Etobicoke Greenway Trail

Trail alignment changes

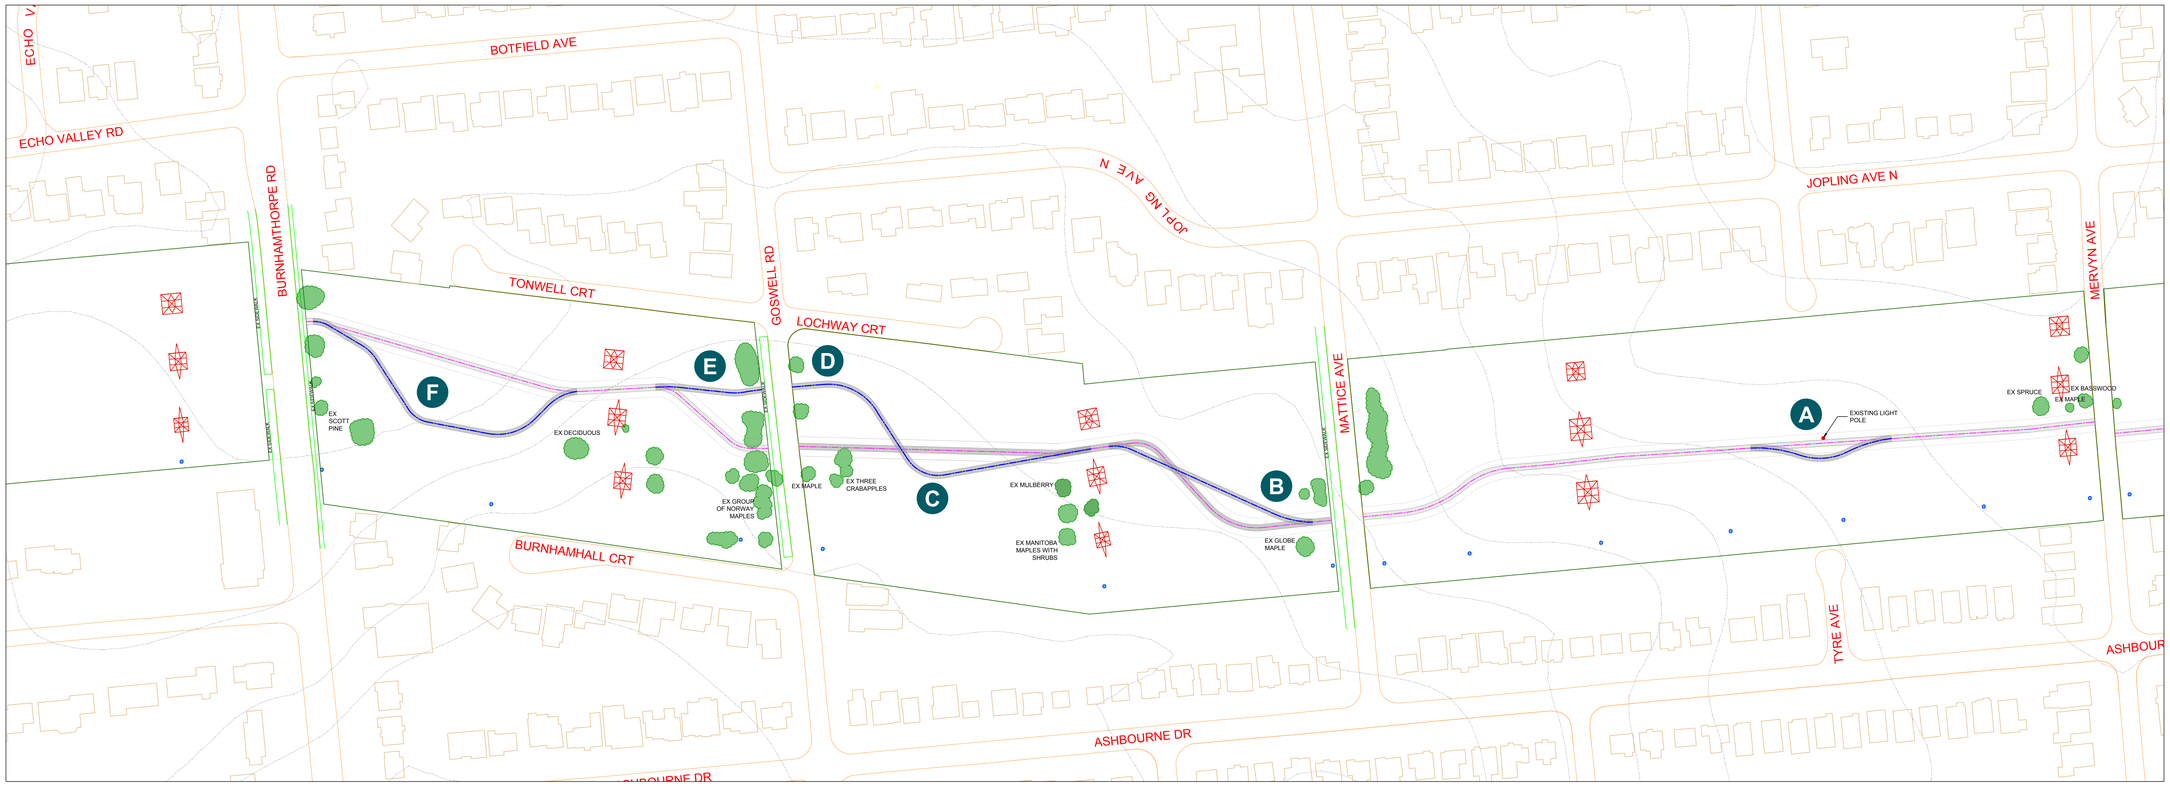
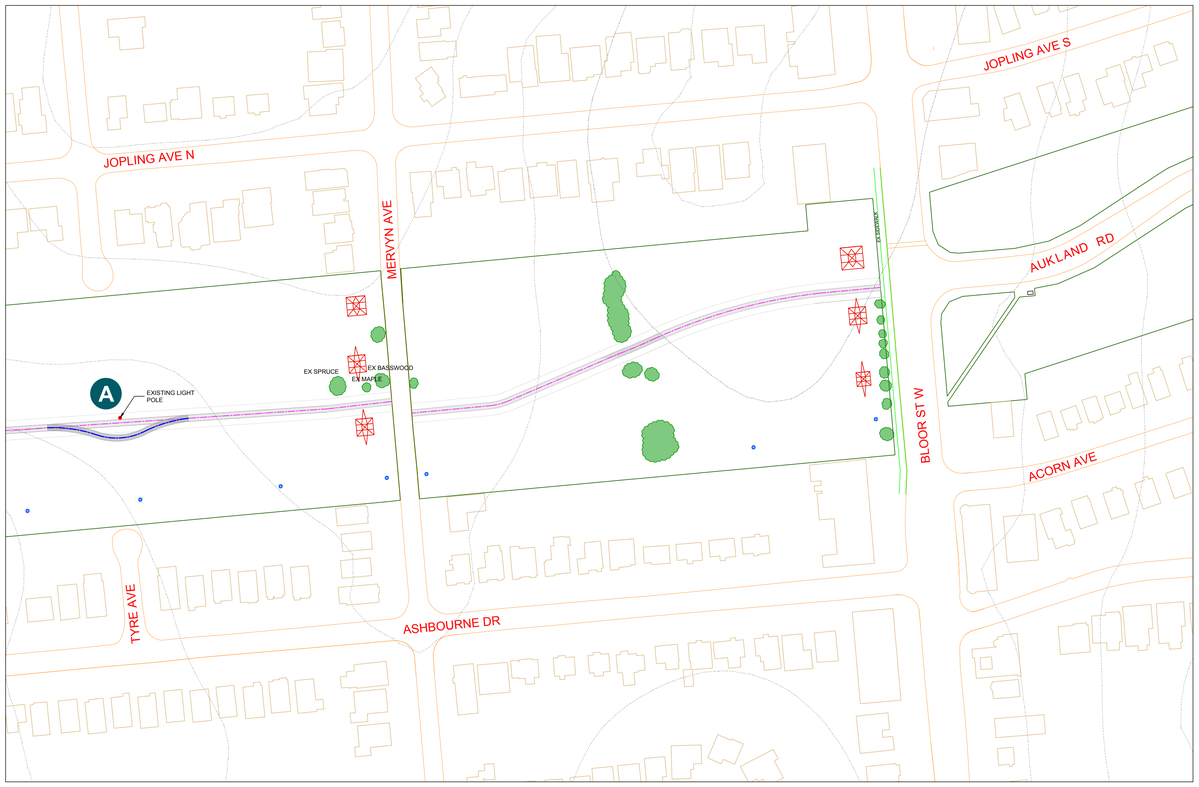
- **A** Required clearance from municipal infrastructure
- **B** Preserve existing maple tree
- **C** Mitigate grading and drainage concerns
- **D** Preserve existing vegetation and align street access points
- **E** Preserve existing vegetation
- **F** Improve grading and mitigate drainage concerns
